Final Drainage Report – Filing No. 1

Waterview East Commercial
El Paso County, Colorado

EDARP File No.: SF269

Scenario: 100-Year

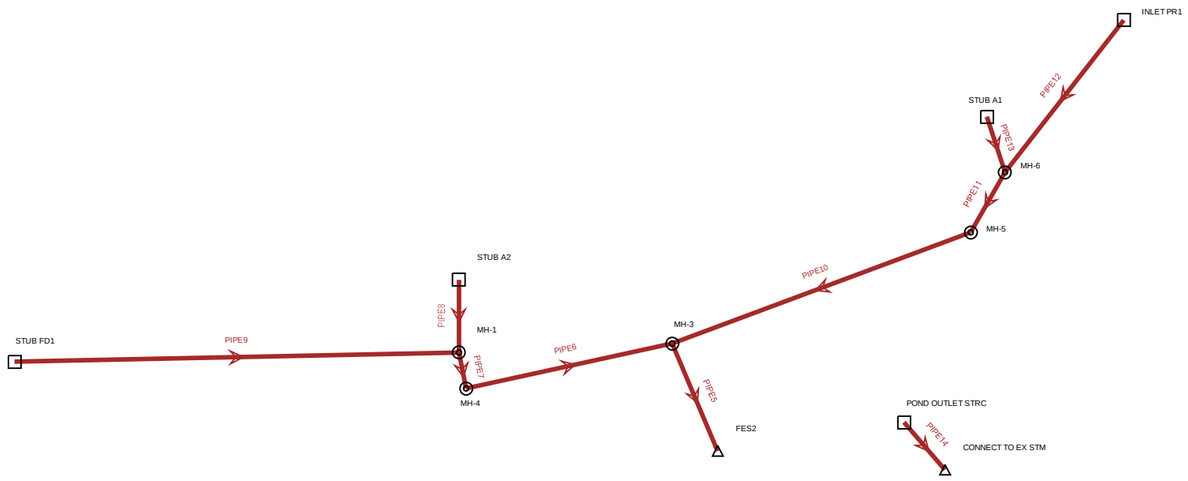
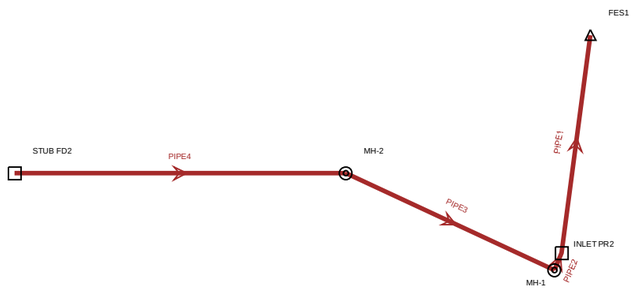
Values do not match CDs. Please revise.

Peak outflow for 5-year per MHFD-Detention spreadsheet is 0.2 cfs. Please revise.

Engineering Profile - STM NW (5-year)

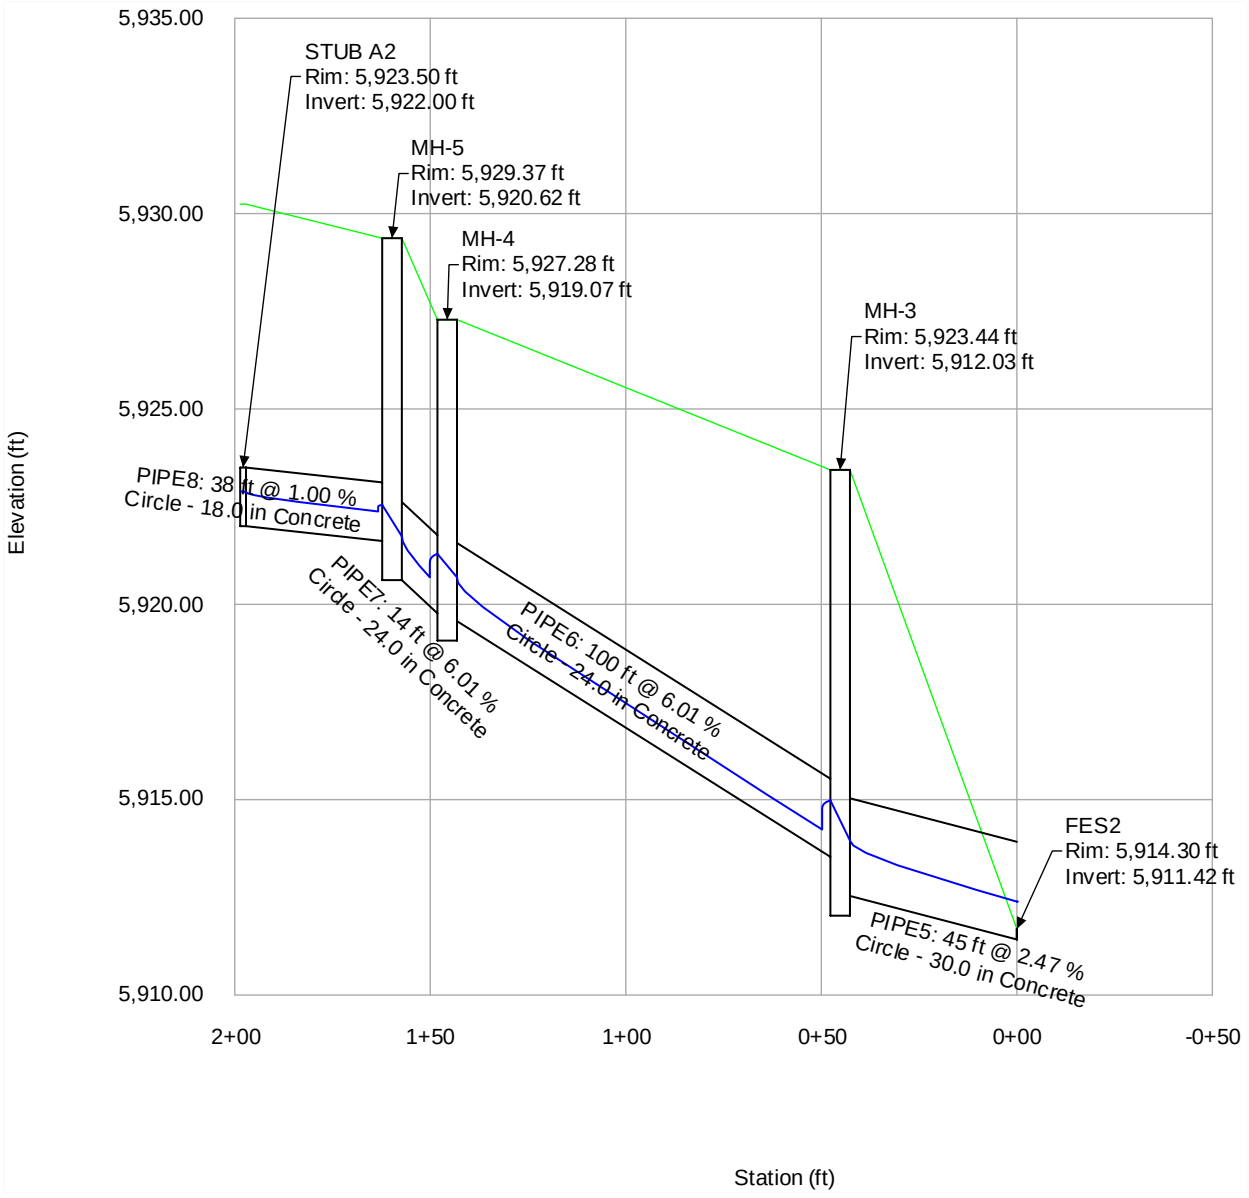
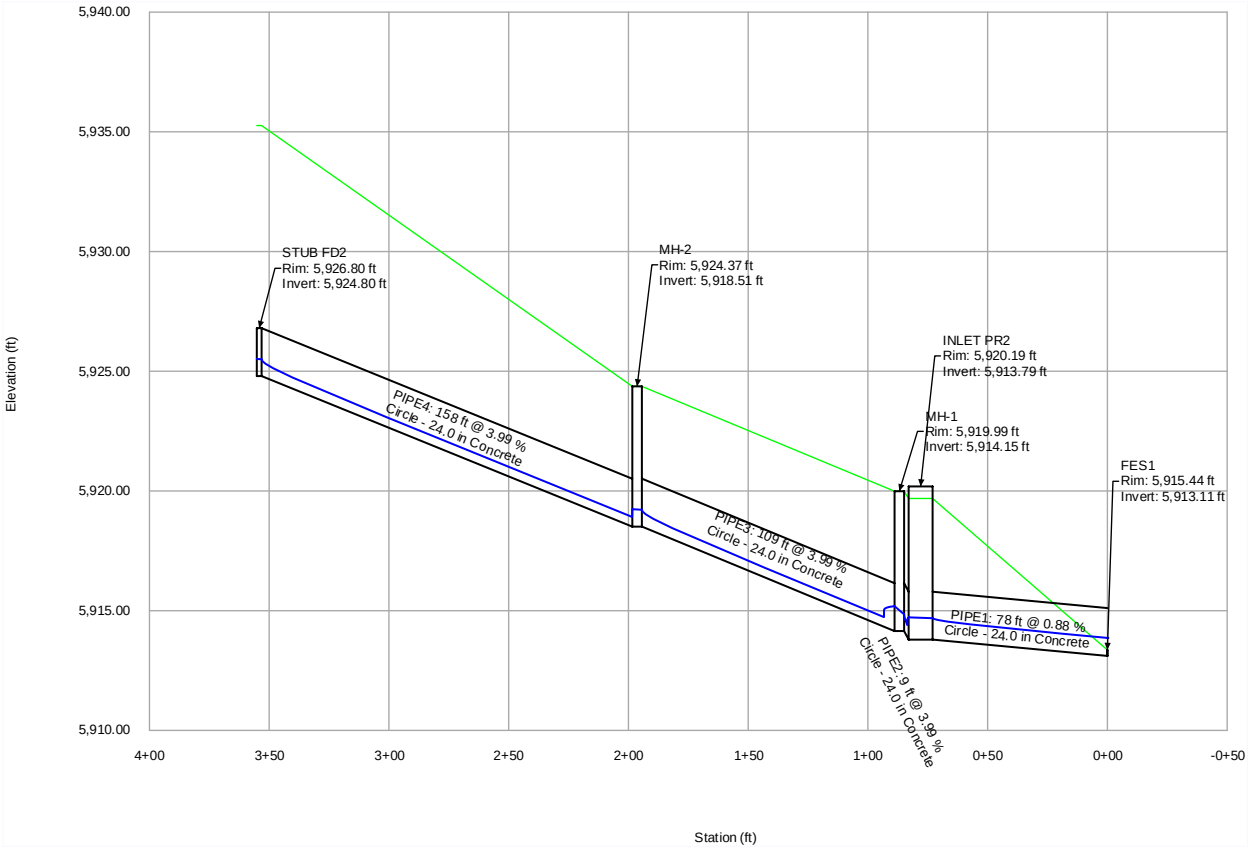
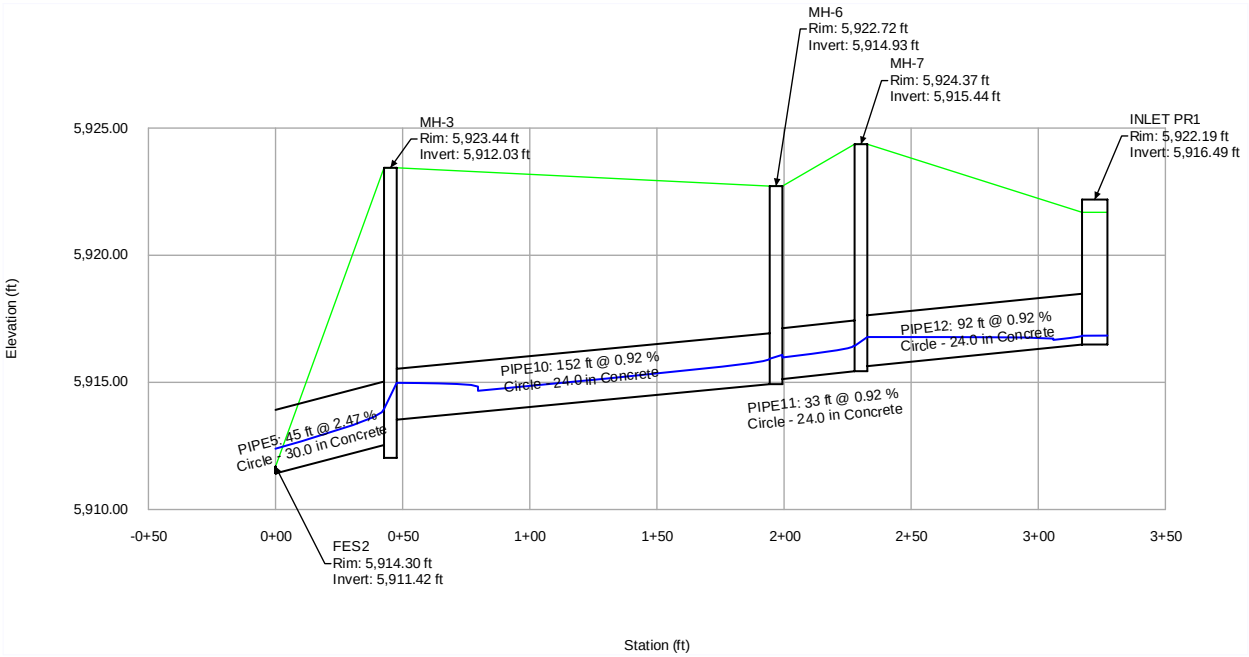
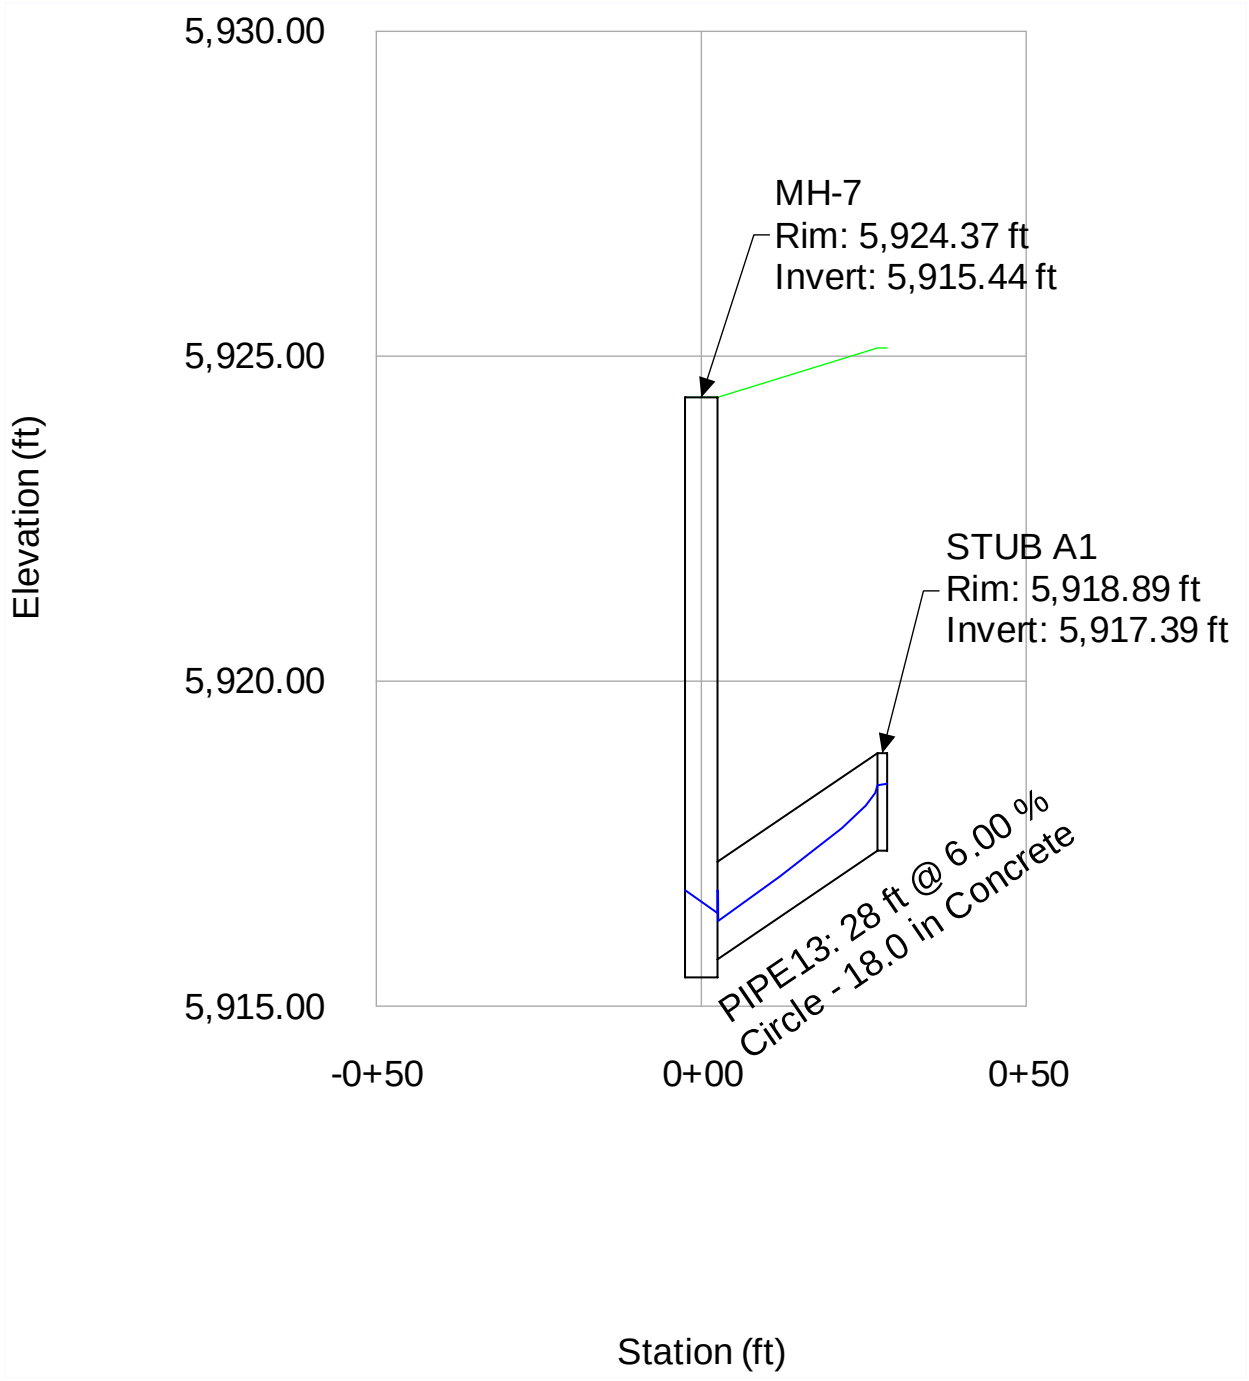
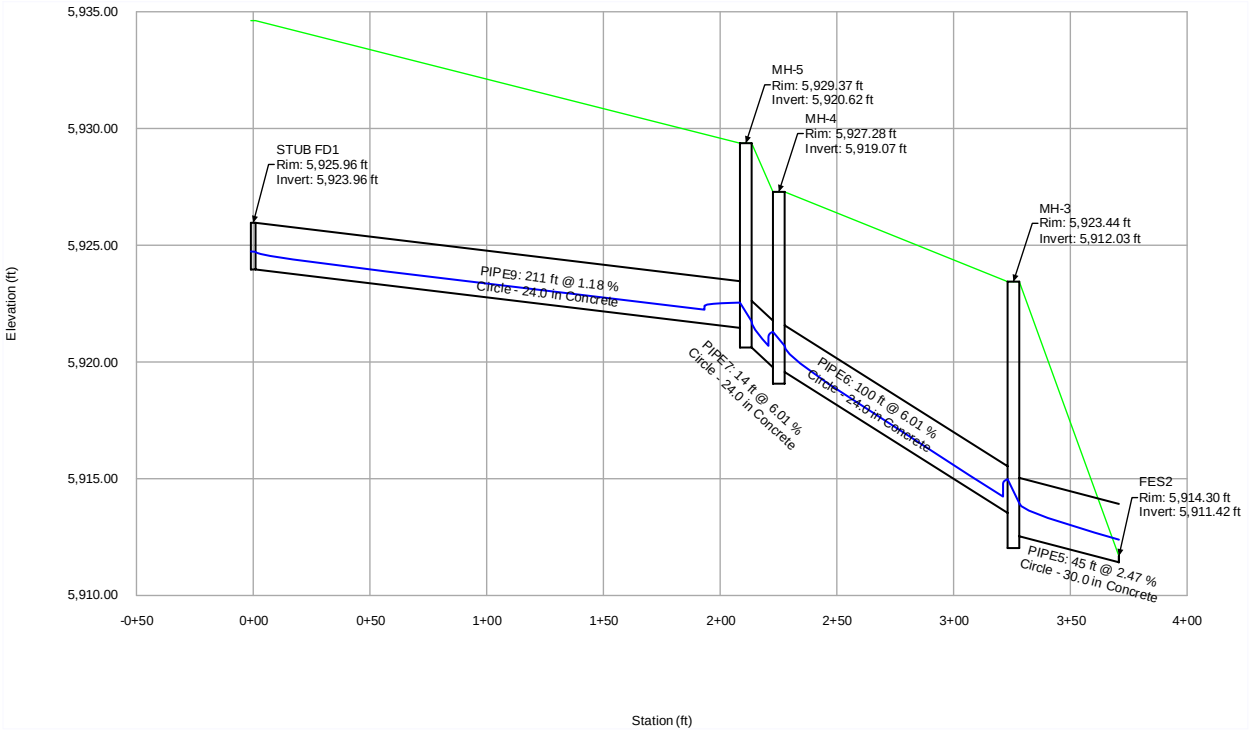
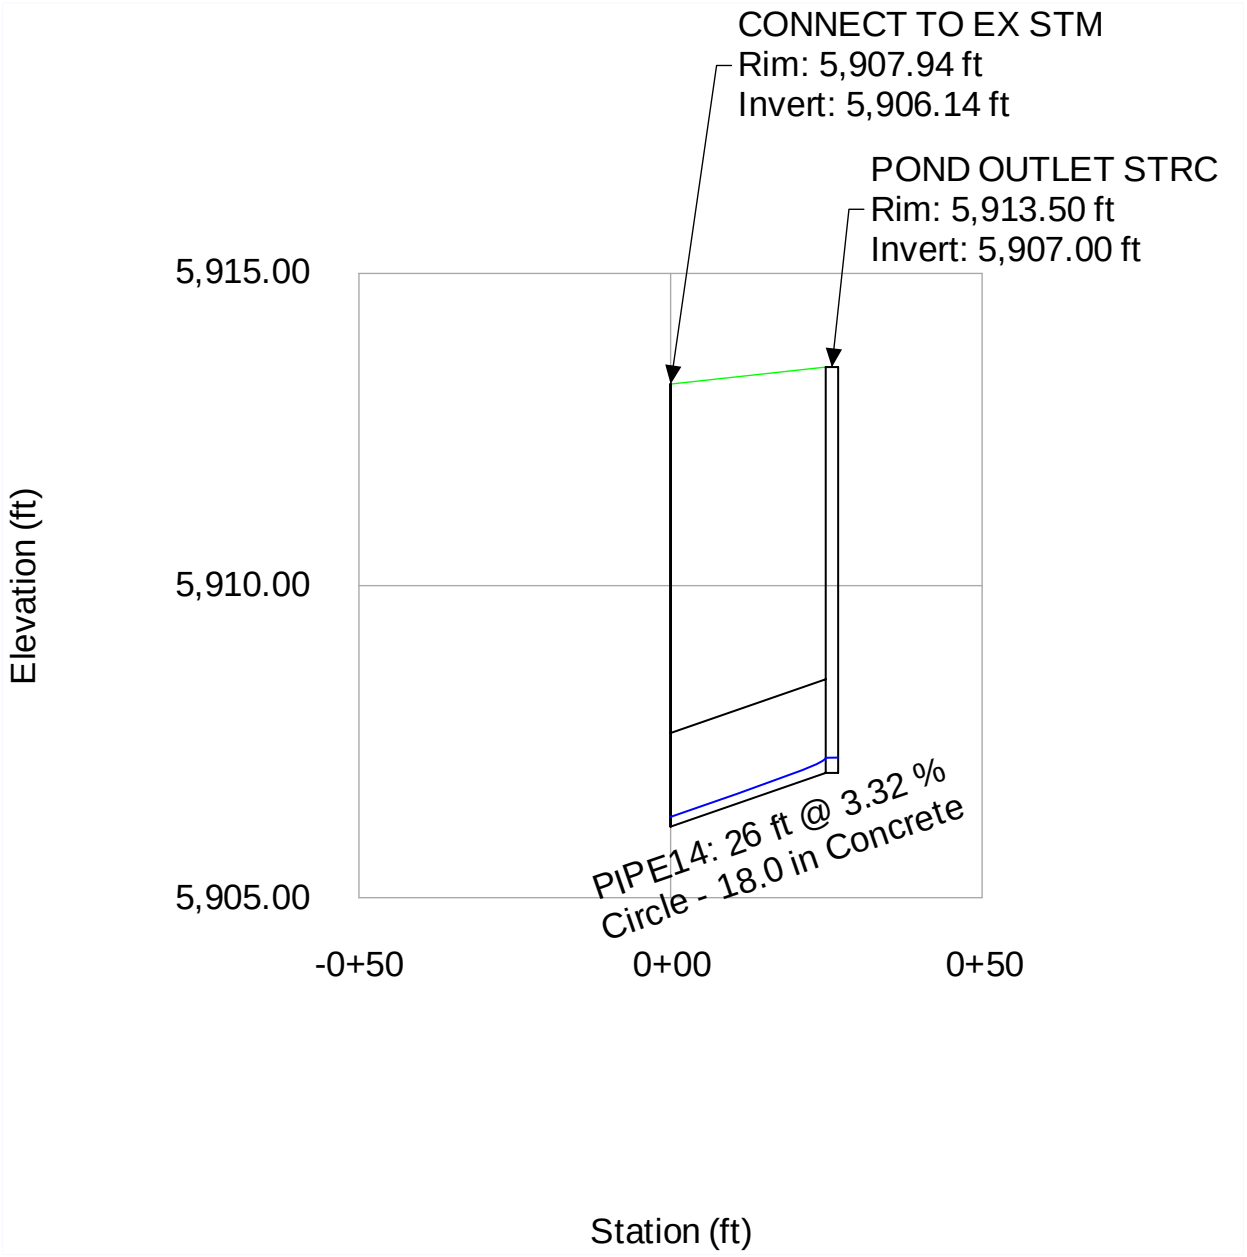
Values do not match CDs. Please revise.

WATERVIEW EAST COMMERCIAL FILING NO. 1
CONSTRUCTION DOCUMENTS
EXISTING DRAINAGE MAP

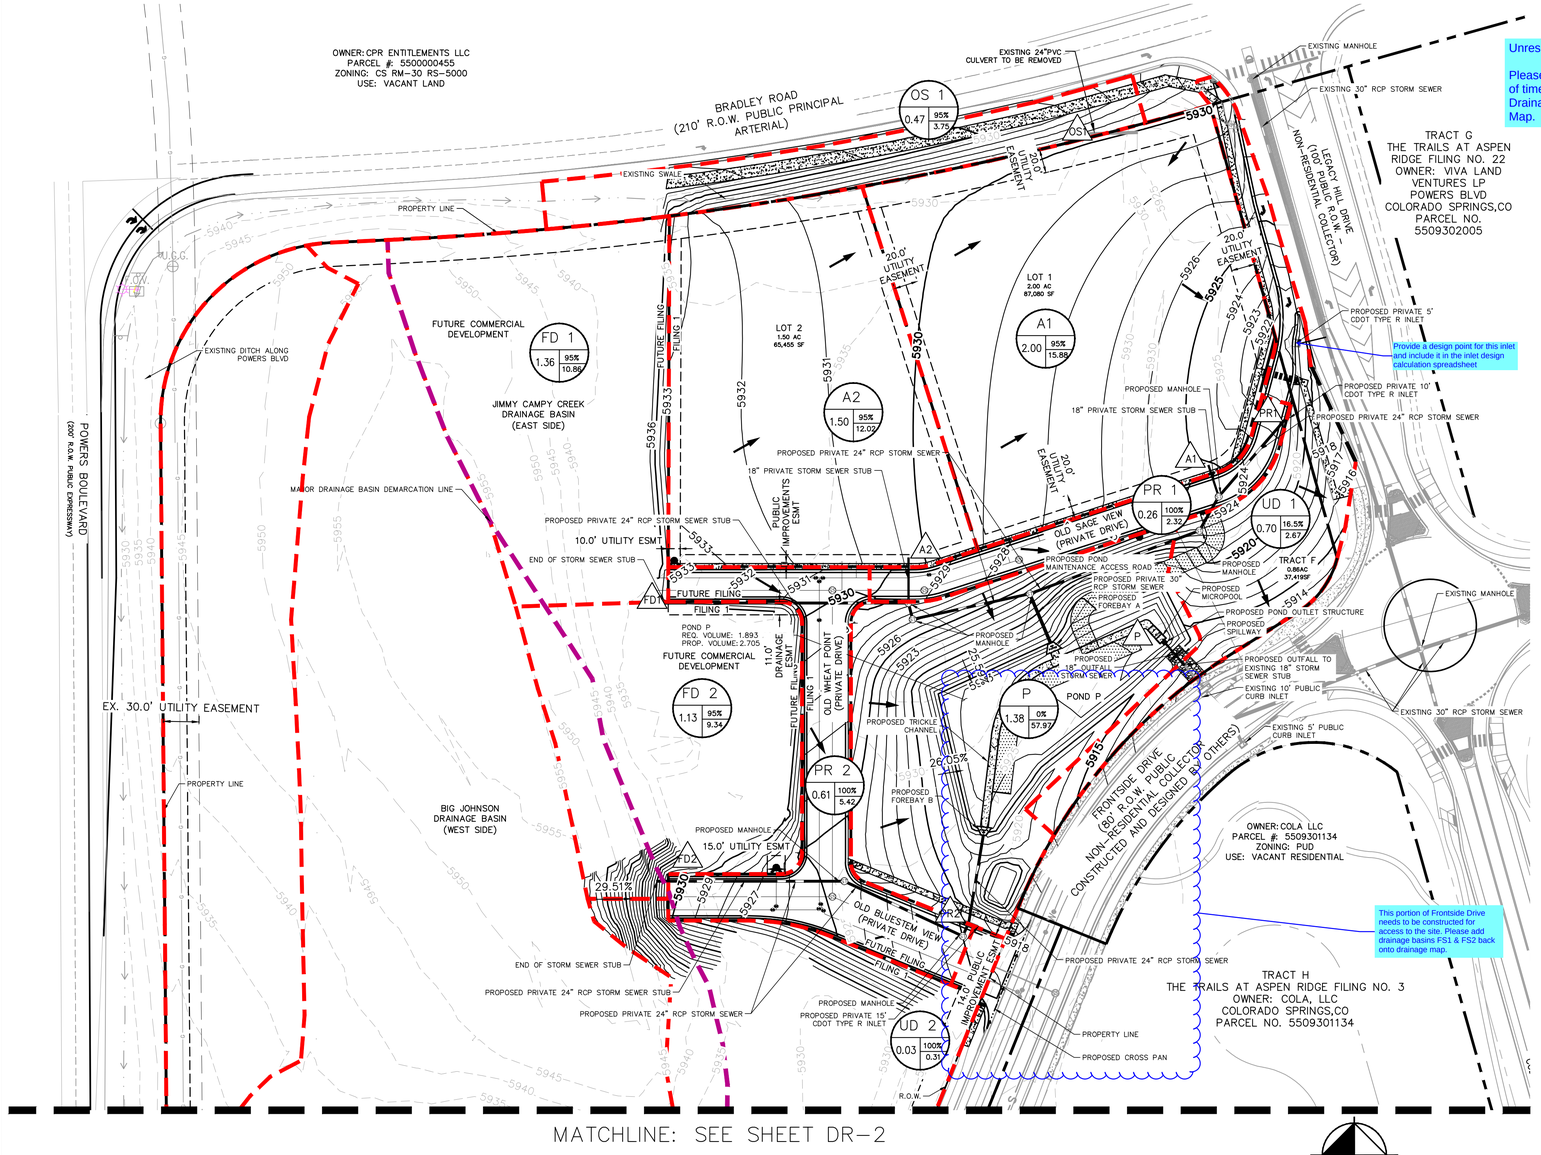
Please show paths chosen for computation of time of concentration on Existing Drainage Map and Proposed Drainage Map.

WATERVIEW EAST COMMERCIAL FILING NO. 1
CONSTRUCTION DOCUMENTS
PROPOSED DRAINAGE MAP

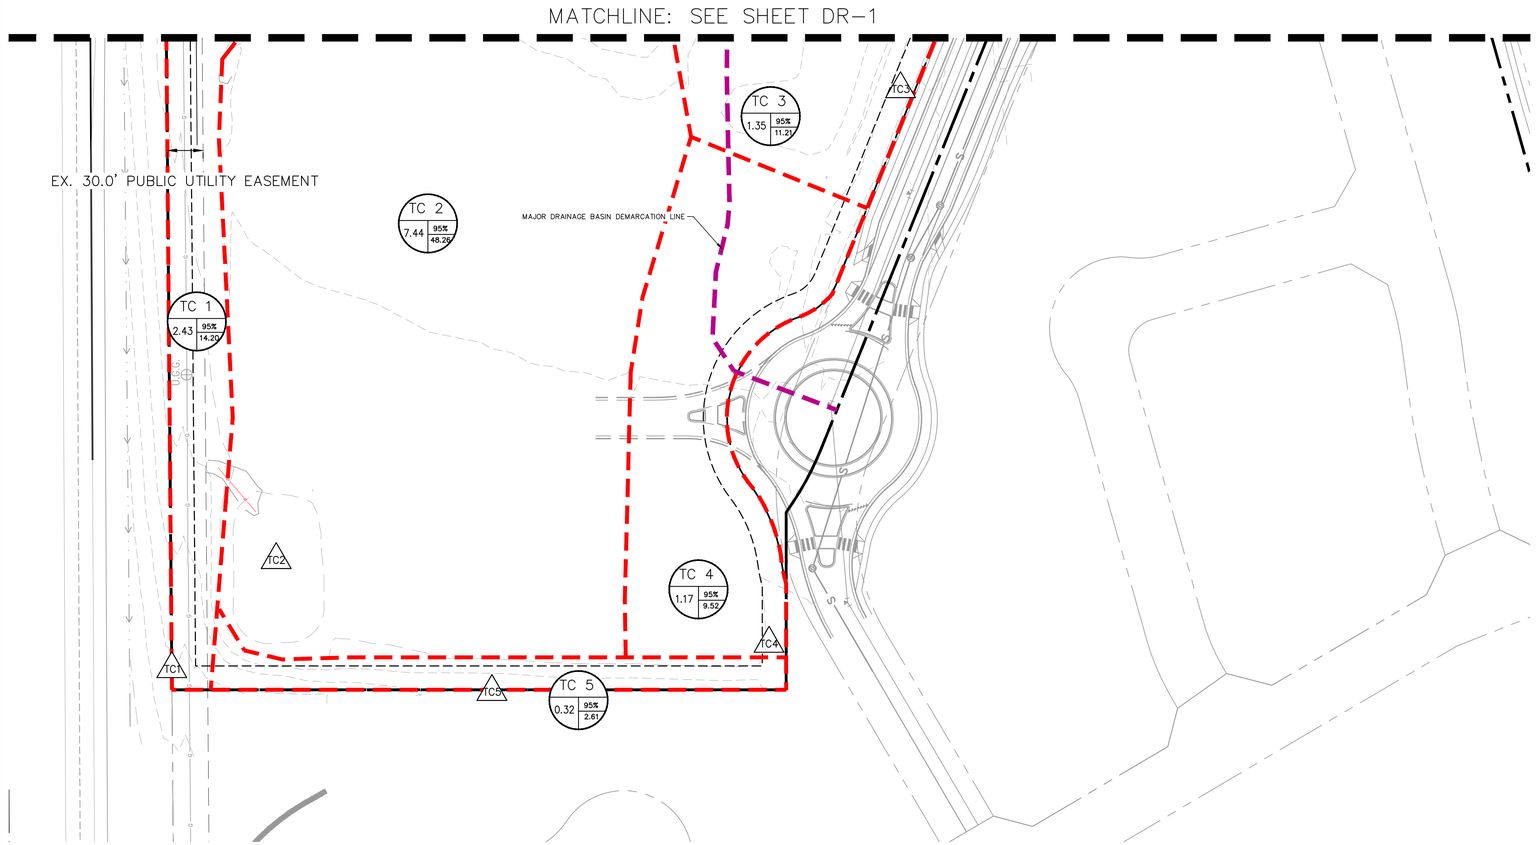
State if proposed inlets are sump or at-grade. Inlet sizes do not match with sizes shown on inlet design calculation spreadsheets. Please verify sizes and revise items as needed

Provide a design point for this inlet and include it in the inlet design calculation spreadsheet

This portion of Frontside Drive needs to be constructed for access to the site. Please add drainage basins FS1 & FS2 back onto drainage map.
